December 16, 2019

Subject: PCN#11A-19 Notification of Intent to Utilize an Alternate Qualified Foundry and Alternate Qualified Mask Sets for the select ECP5U and CrossLink Products

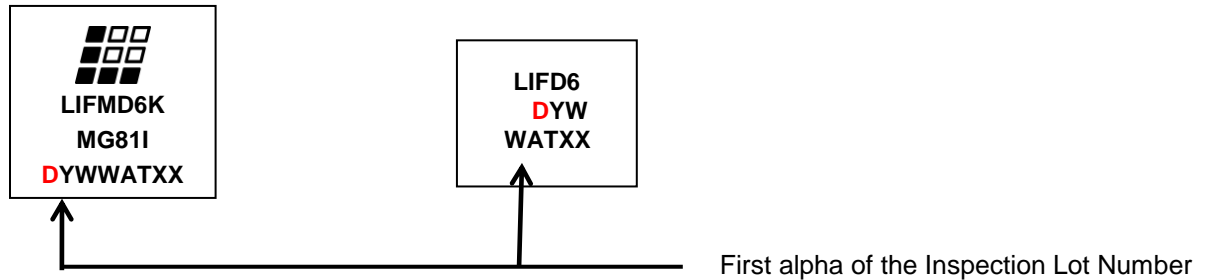
Devices with this new alternate qualified mask set can be identified by the first alpha character of the Inspection Lot Number for the alternate fab manufactured product, which is marked on the topside of the device. Inspection lot numbers are also marked on the label on the outside of the inventory box as well as on the anti-static moisture barrier bag within. See device topside marking examples below:

For LFE5U products the alternate foundry first alpha character is a “B”.
